Access Compliance Report

Public Rights-of-Way

(Curb Ramps)

Intersection ID: N/A	Main Street: SCOFIELD_RD	Cross Street: WINTERCREST_LN	Location: E
ADA ID: 470E24D07FC5	Ramp Type: PerpDiag	Initial Pass/Fail: Fail	Overall Compliance: No
Severity Score: 1.25			
Codes/Mitigation Info/Possible Solution		Field Measurements/Component Compliance

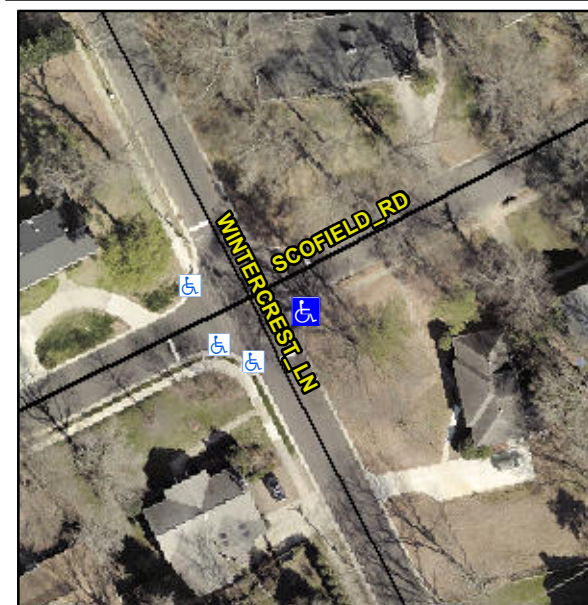
Not Found, R304.5.3

Compliance	Description	Data	Compliance	Description	Data
N/A	Ramp Length (in)	43.0	Yes	Ramp Slope (%)	5.2
Yes	Ramp Width (in)	48.0	No	Ramp XSlope (%)	4.1
N/A	Flare Type LT	N/A	N/A	Flare Type RT	N/A
N/A	Flare Slope LT (%)	N/A	N/A	Flare Slope RT (%)	N/A
N/A	Flare Traversable LT?	N/A	N/A	Flare Traversable RT?	N/A
N/A	Landing Length (in)	N/A	N/A	DWS Provided?	N/A
N/A	Landing Width (in)	N/A	N/A	DWS Contrast?	N/A
N/A	Landing Slope (%)	N/A	N/A	DWS Length (in)	N/A
N/A	Landing X Slope (%)	N/A	N/A	DWS Full Width?	N/A
N/A	Landing Curb? (Y/N)	N/A	N/A	DWS Offset (in)	N/A
N/A	Shared Landing?	N/A			
N/A	Gutter Ponding?	N/A	N/A	Gutter Slope (%)	N/A
N/A	Gutter Lip Ht (in)	N/A	N/A	Gutter X Slope (%)	N/A
N/A	Painted X Walk1?	No	N/A	Painted X Walk2?	No
	X Walk 1 Direction	To N		X Walk 2 Direction	To SW
N/A	X Walk 1 Width (in)	N/A	N/A	X Walk 2 Width (in)	N/A
	X Walk 1 Slope (%)	4.4		X Walk 2 Slope (%)	1.9
	X Walk 1 X Slope (%)	2.9		X Walk 2 X Slope (%)	4.3

Remove & Replace Curb Ramp With Two New Directional Ramps or Equivalent.
